Plan Commission

Agenda

Monday, September 26, 2022

Subject ***Town and Country - Storage Shop USA***
PIP Resubmittal: PIP Narrative and Response to City Comments
JSD Project No. 20-9800A

SHEET NUMBER:
C1.0

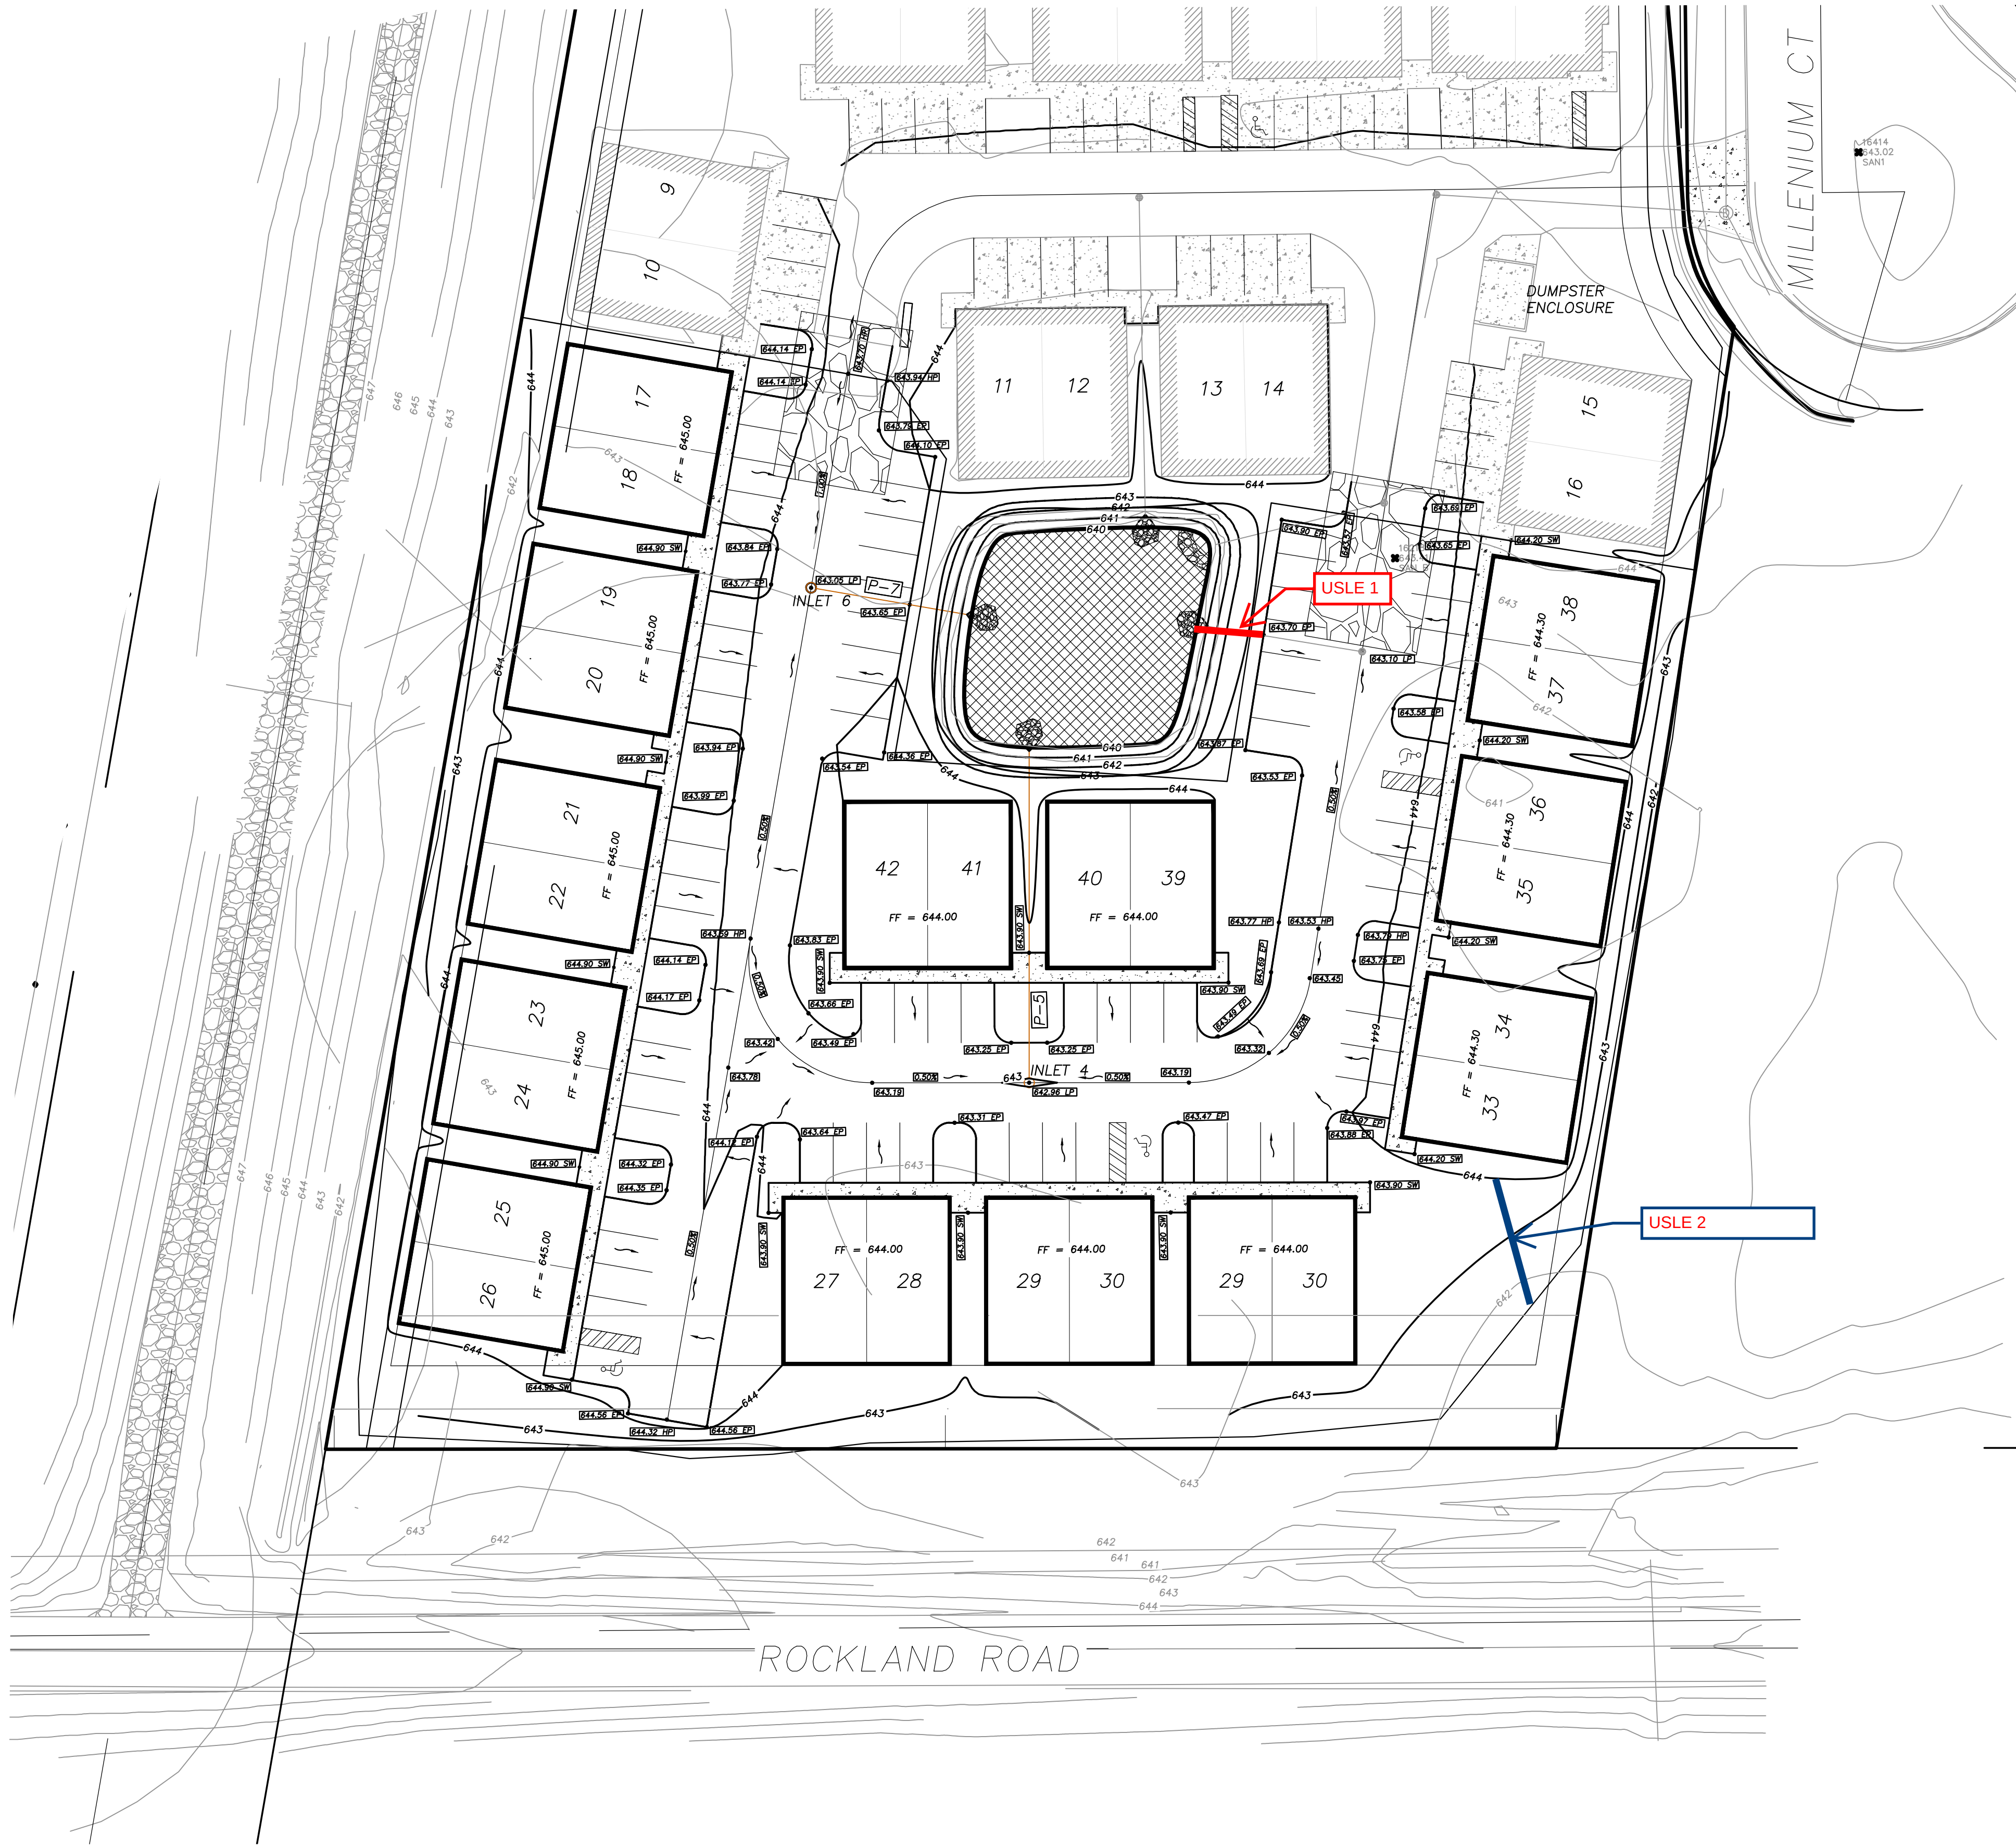
4. Specify the dates for the completion of Phase 2 and Phase 3 within the PIP supporting document and on the plans.

JSD Response: Dates have been added to the Site Plan Sheet C1.0 and in the PIP Narrative letter.

PRECISE IMPLEMENTATION PLAN

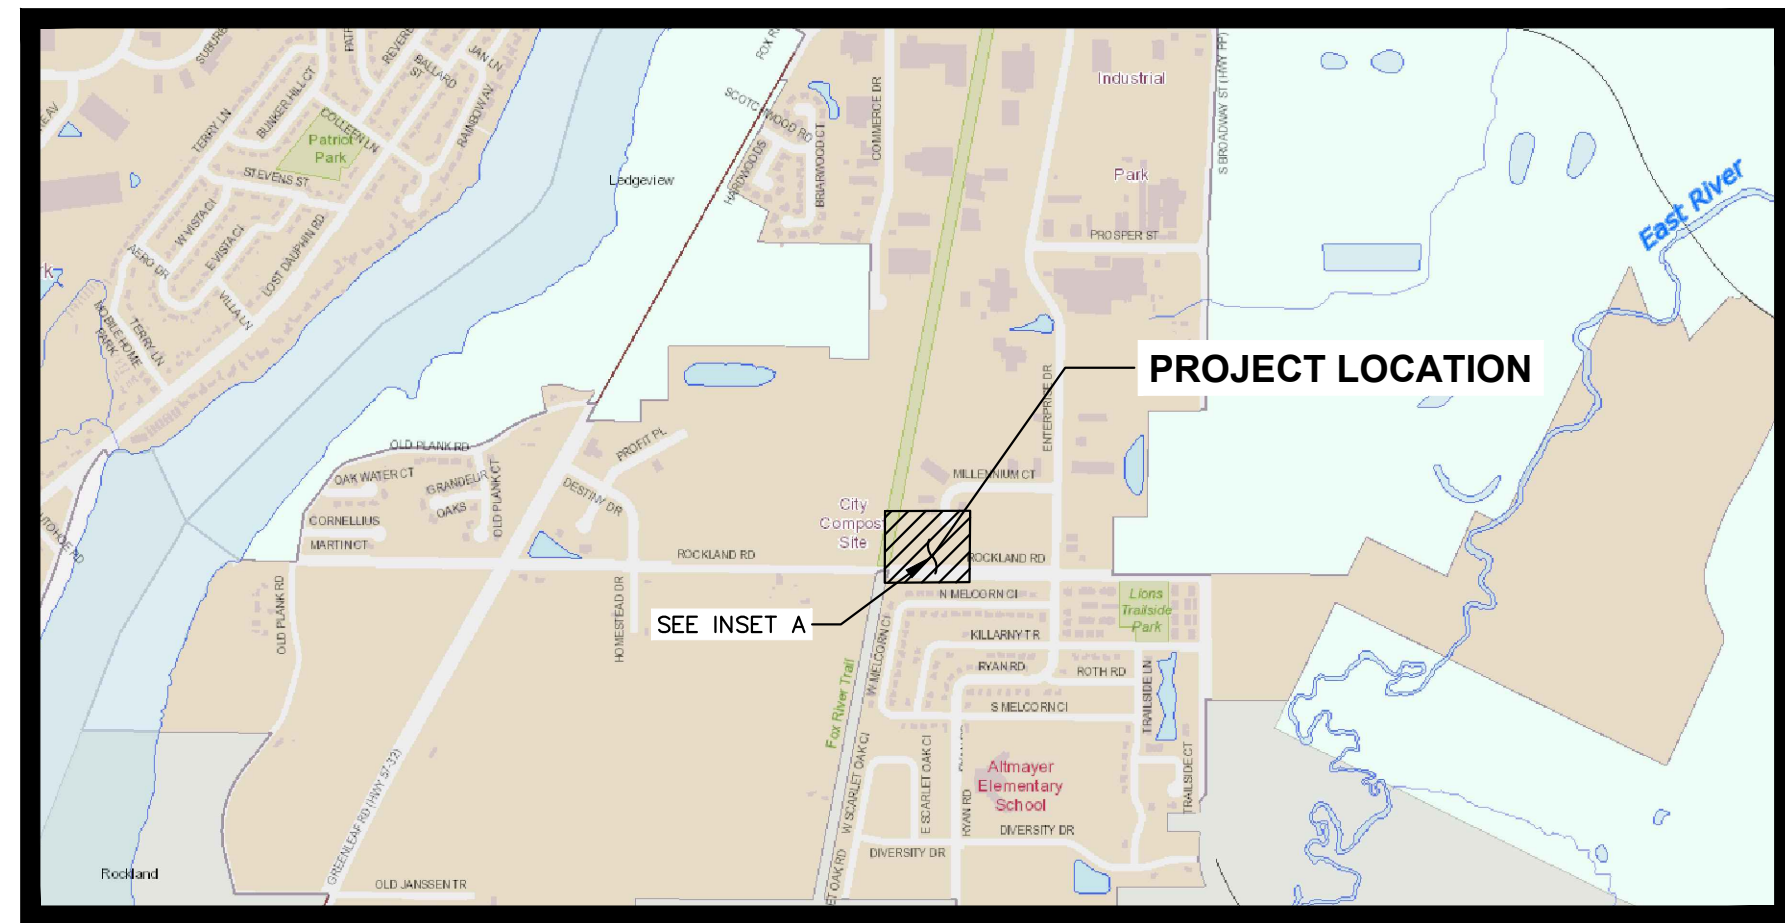
1. The documents need to be clearly labeled "Precise Implementation Plan." Ensure that there is a document or a page that is dedicated to spelling out anything that is not conforming to the underlying zoning that is being specially requested as part of this project.

JSD Response: See Title Sheet: Precise Implementation Plan was added to the sheet.

LANDSCAPE PLAN

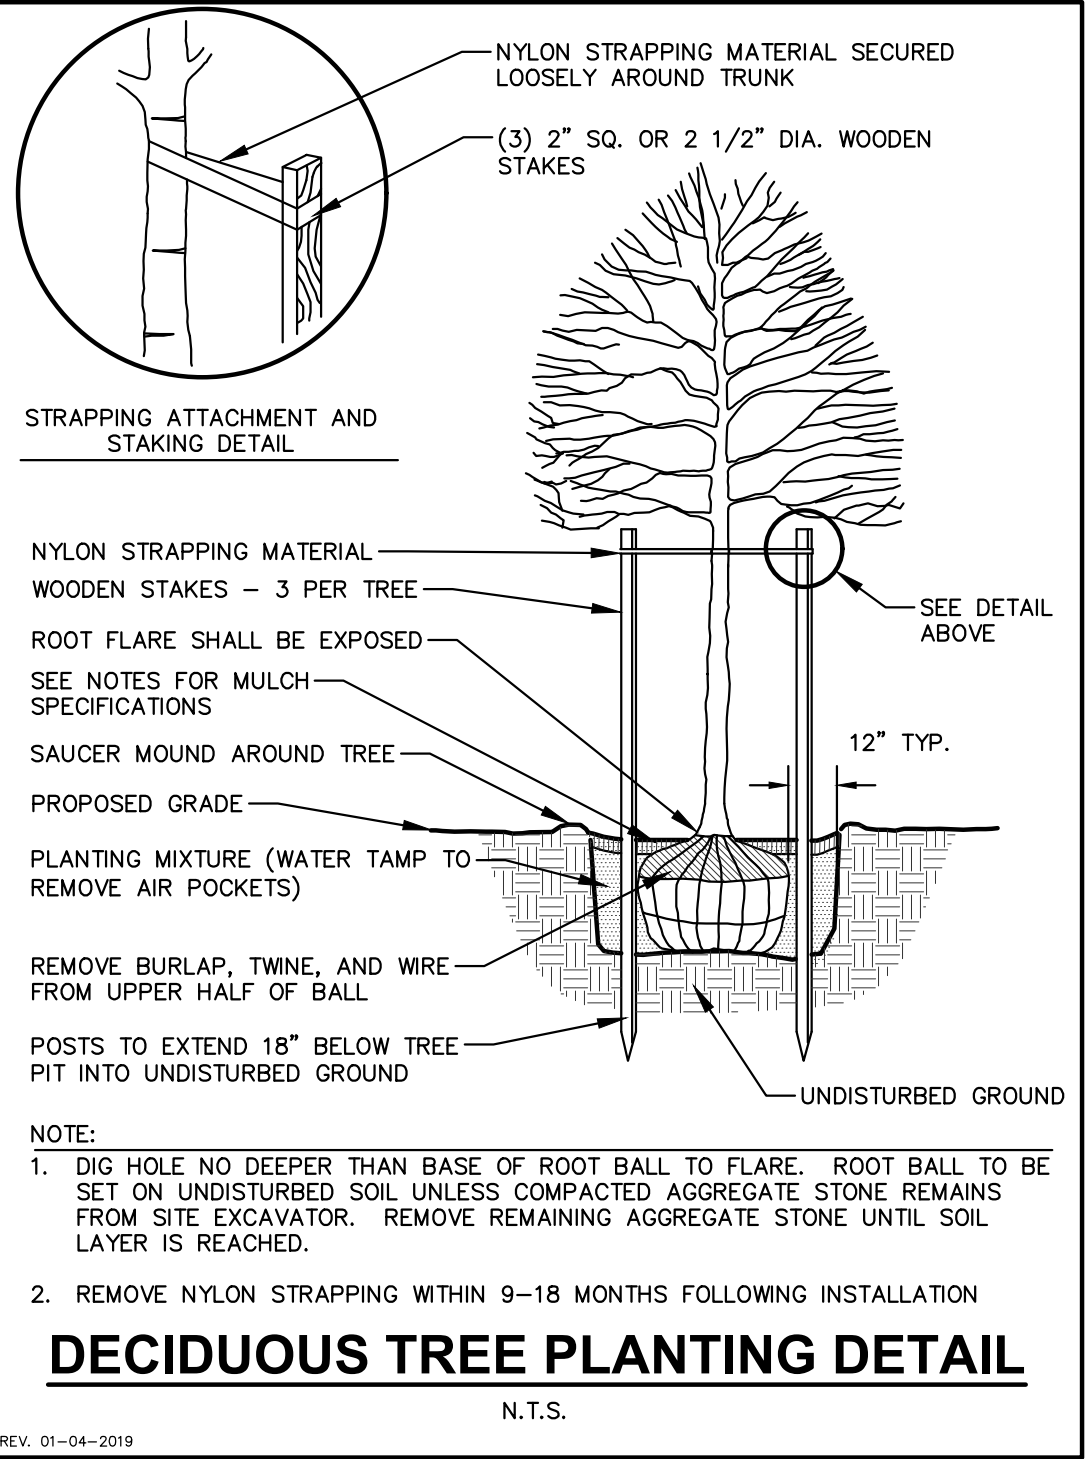
2. Clarify that the Landscape Plan on Sheet L1.0 is to proper scale as the requested four trees (New Horizon Elm) on Rockland RD appear to be outside of the property boundaries.

JSD Response: Landscape Plan has been updated with the trees repositioned to be on the property.
